HISTORIC PRESERVATION COMMISSION STAFF REPORT

Address: 240 Mowbray Road, Silver Spring

Review: Preliminary Consultation

PROPOSAL: Alteration/Addition

South Elevation

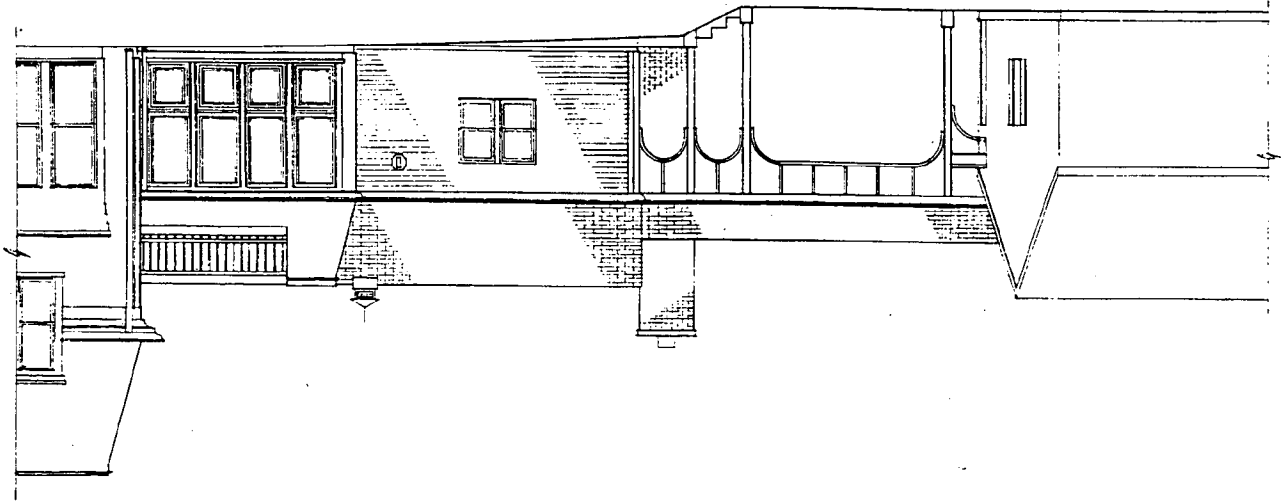
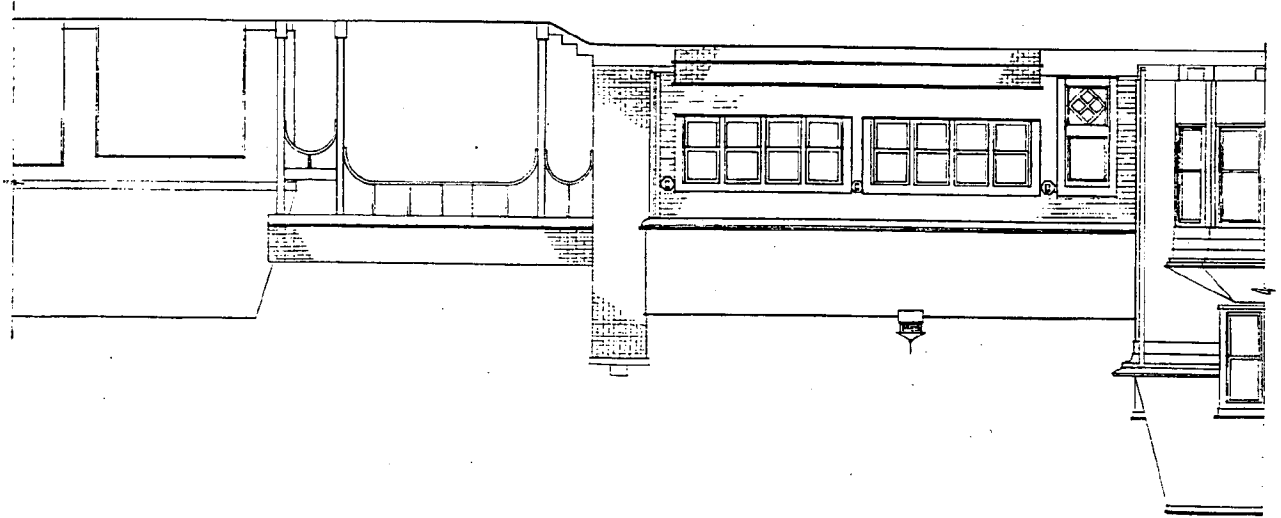
JT - front of garage should not look like recon'd garage ->

WEST ELEVATION - OUT GARAGE
1/2/10

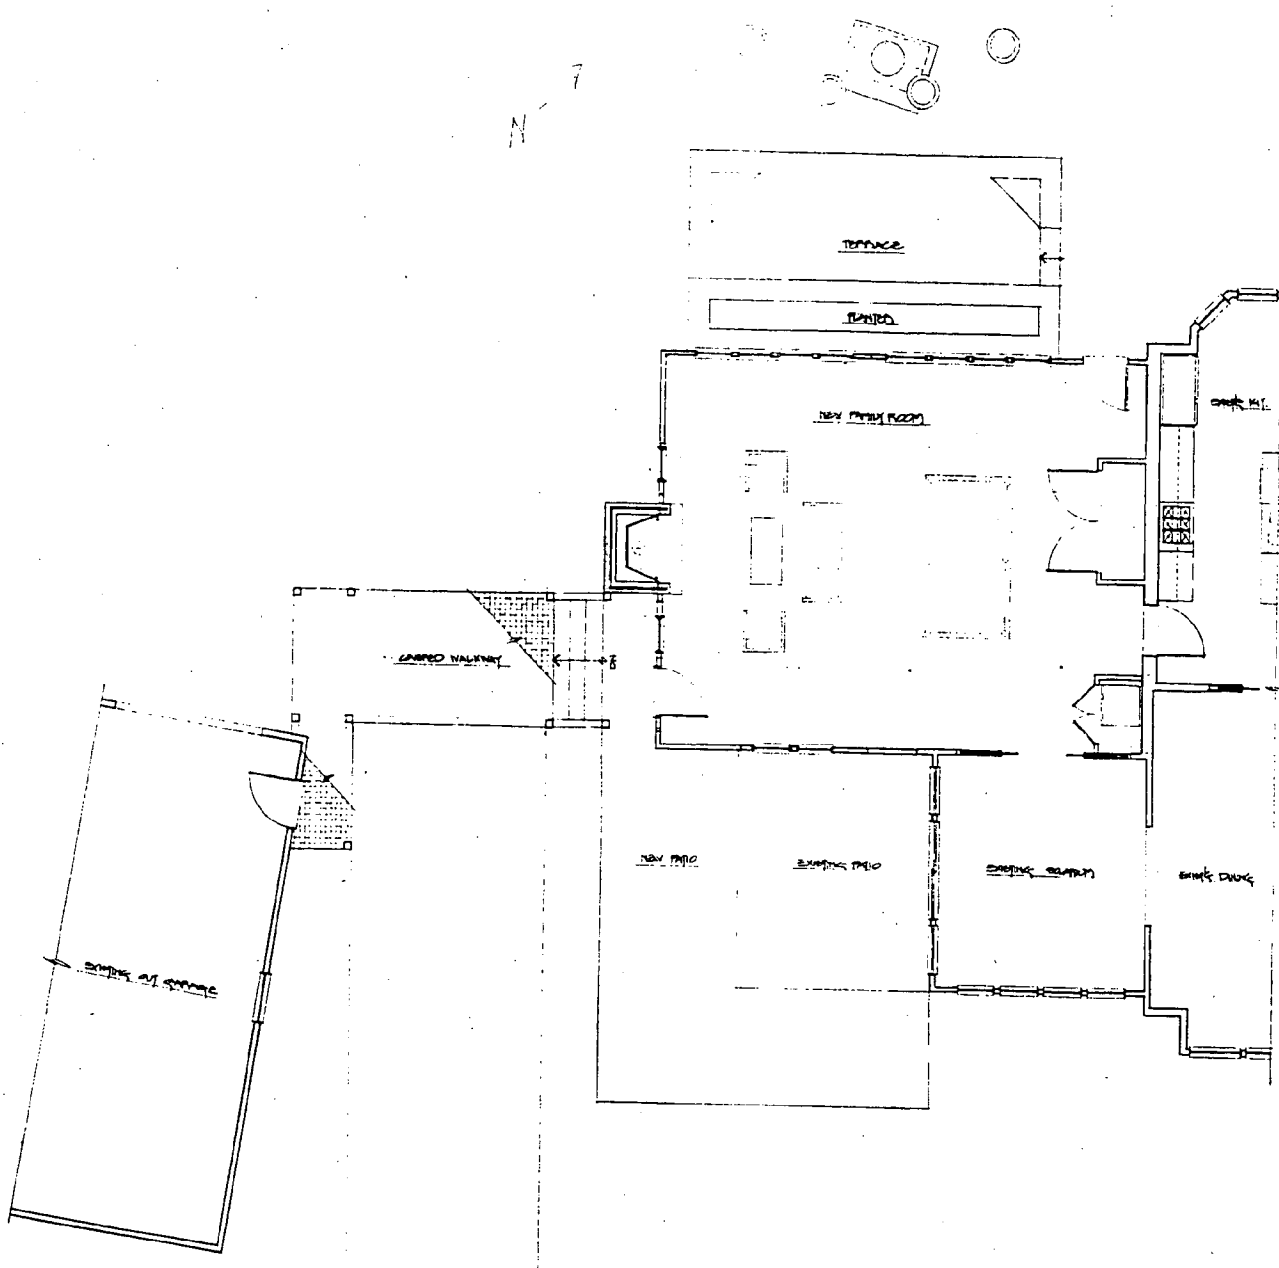
DL reply - glue stone paving, planters (pots)
(raised terrace) (18" above grade)

14-10
WEST ELEVATION - OUT GARAGE

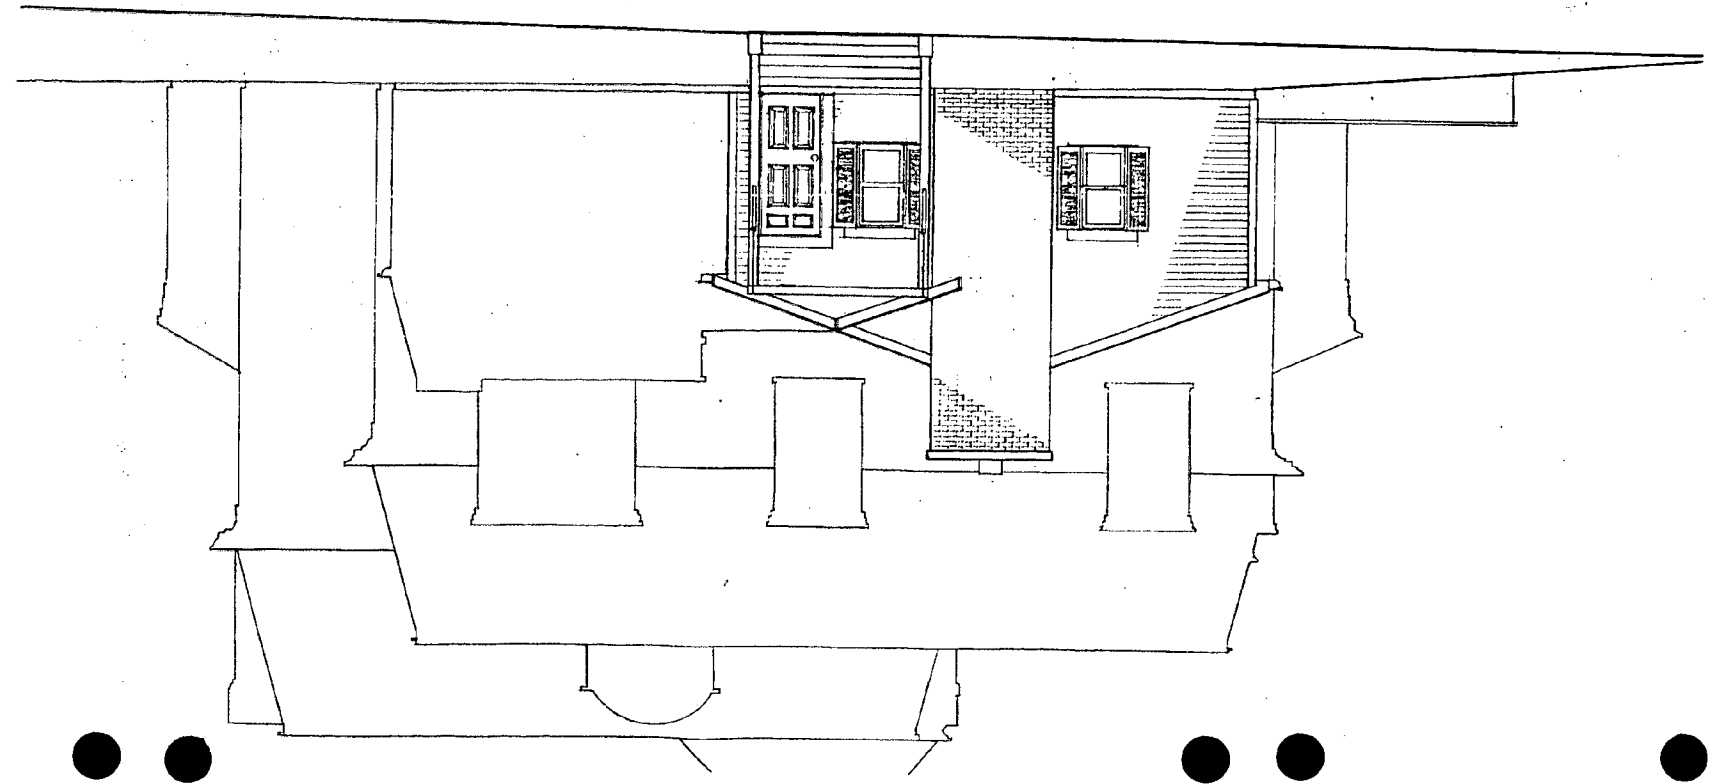
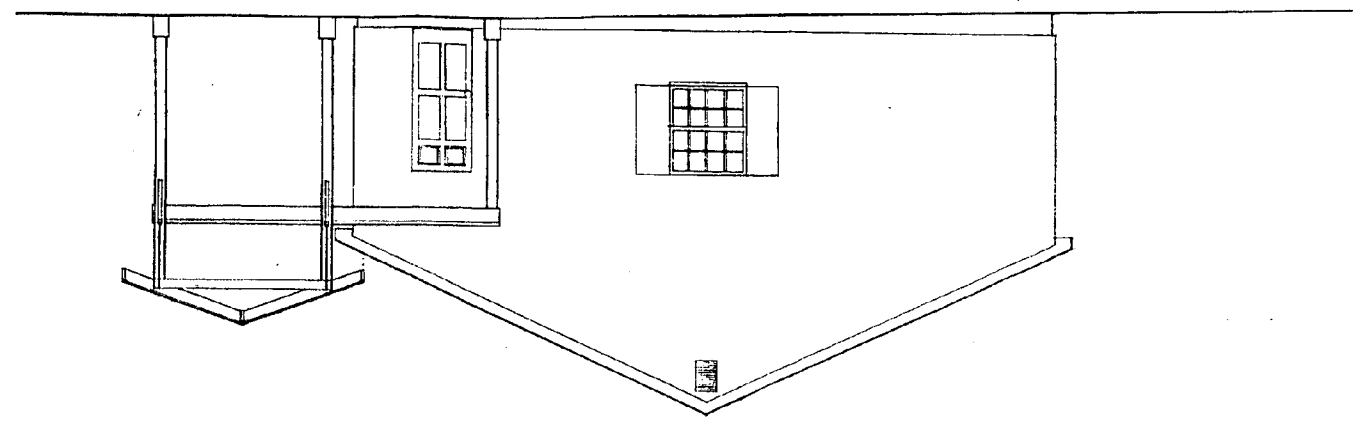
Staff is concerned that while the proposed chimney is in proportion with the scale of the short, wide, rambler configuration of the garage/family room, it is a substantial departure from the design of the original house. Staff suggests that the chimney design might be modified to achieve a better balance if the chimney cannot be eliminated entirely.

- Consideration should be given to integrating the proposed window and door design and materials with that of the original building.
- The design of the proposed chimney should be brought more in line with the Victorian style of the original house.
- The proposed walkway should be placed such that it will not add more out-of-period mass, and designed in as simple a style as possible.

Soderberg - garage banks of windows broken up e.g. 4 banks of 2 instead of 2 banks of 4.
Chimney window banks
